PARK CITY PLANNING COMMISSION MEETING
SUMMIT COUNTY, UTAH
March 24, 2021

5.A. 9300 Marsac Ave (Sommet Blanc/B2East Parcel) – Applicant is Requesting a Work Session Before the Planning Commission Prior to Public Hearings for a Conditional Use Permit and Amendments to the Approved Master Planned Development and Flagstaff Development Agreement for Proposed Development of 43 Residential Units Above Underground Parking, and 5 Condominium Villas on the North-eastern Portion of the Site on the B2East Parcel. PL-20-04702.

6.D. Park City Mountain Resort Base Parking Lots - MPD Modification - Replace Expired Exhibit D of the DA, the 1998 PCMR Base Area Master Plan Study Concept Master Plan, With a New Master Plan, Known as the Park City Base Area Lot Redevelopment Master Plan Study. This Hearing Will Focus On the Applicant's Proposed Circulation and Transportation Plans, Scenario 2b, in Accordance with the MPD, and Applicable LMC, General Plan and Transportation Master Plan Criteria. PL-20-04475.
Public Input will be taken via e-comments

Scenario 2b **Parking & Driveways**

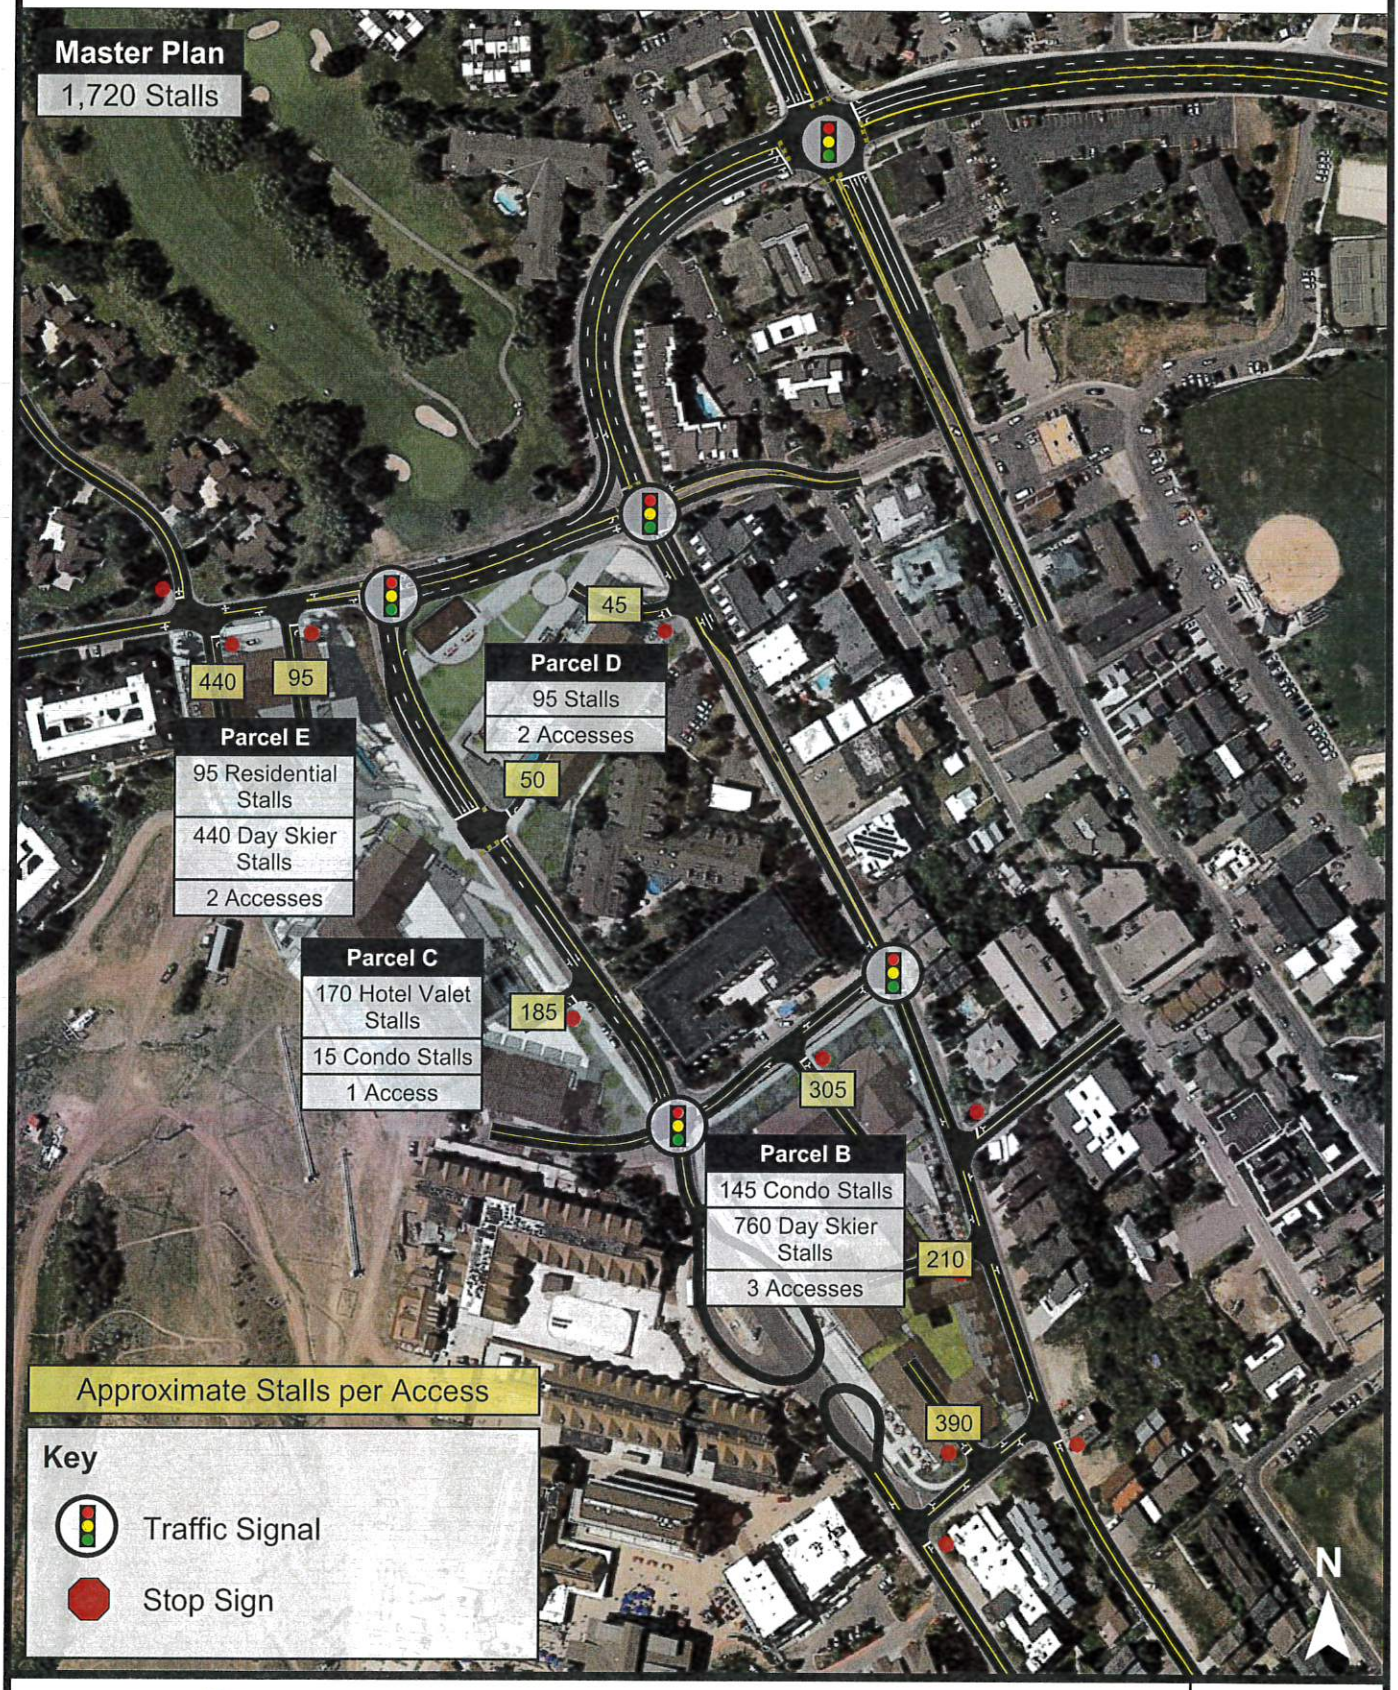
PARCEL	Current PEG Exhibits	Noted Discrepancy	Question/Concern
B	68 Condominiums and 89 Employee Housing Units (Appendix A) 145 condo parking stalls (Figure 4)	Staff Report only 87 parking stalls for condos. No stalls indicated for Employee/Affordable Housing. (Page 17)	Parking stall calculations do not add up by category or in total.
	905 parking stalls (53% of all parking) is now located on this parcel alone. (Figure 4)	Staff Report states only 873 stalls located on this parcel. (Page 17) Increase of 32 stalls.	Parking stall calculations do not add up by category or in total.
C	249 Hotel rooms (Appendix A)	250 Hotel Rooms per Jan 20th, 2021 Building Re-Design Programming report for Parcel C	
	170 Hotel Valet Stalls (Figure 4)	Staff report - 183 Valet Parking Stalls (Page 17)	
	15 Condo Stalls (Figure 4)	ZERO Condo stalls – No condos identified in Jan 20th, 2021 Building Re-Design Programming report for Parcel C.	Why are there parking stalls for condos if no condos located on parcel?

5. It has yet to be determined where service vehicles such as maintenance, cleaning, appliance delivery and so on will park.
6. Figure 4 Parking & Driveways raises the following notable potential issues:
